Request IR-1:

This IR response has been provided by The Brattle Group.

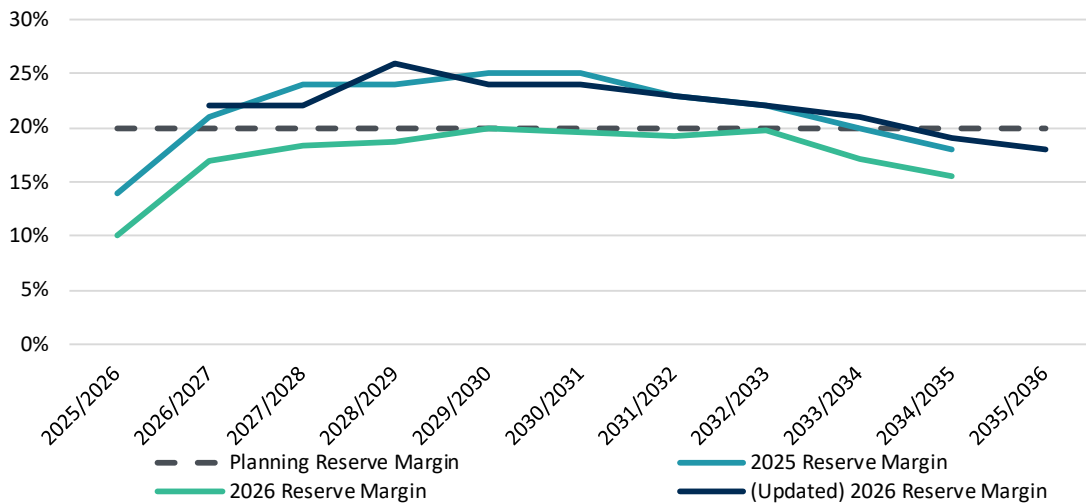
(a) Please update Brattle's Figure 1 using the most recent data from the 2026 System Outlook and confirm whether the updated data changes Brattle's analysis or recommendations.

(a) An updated Figure 1 which reflects the data from the IESO-NS 2026 10-Year System Outlook (10YSO) Report is provided on the next page.

The IESO-NS 2026 10YSO improves the reserve margin, closer aligned with the 2025 reserve margin. The updated 2026 reserve margin is on average five percentage points higher than the initial 2026 reserve margin based on NS Power's 2025 10YSO Report. While the load forecast is relatively unchanged from the 2025 load forecast, capacity levels have improved due to changes to accreditation compared to 2025 and changes to the additions and retirements schedule, among others. Notwithstanding that these developments improve the reserve margin, with expected load growth, DR continues to have great option value and will be an important tool for quick response to load growth. These developments do not alter Brattle's recommendations.
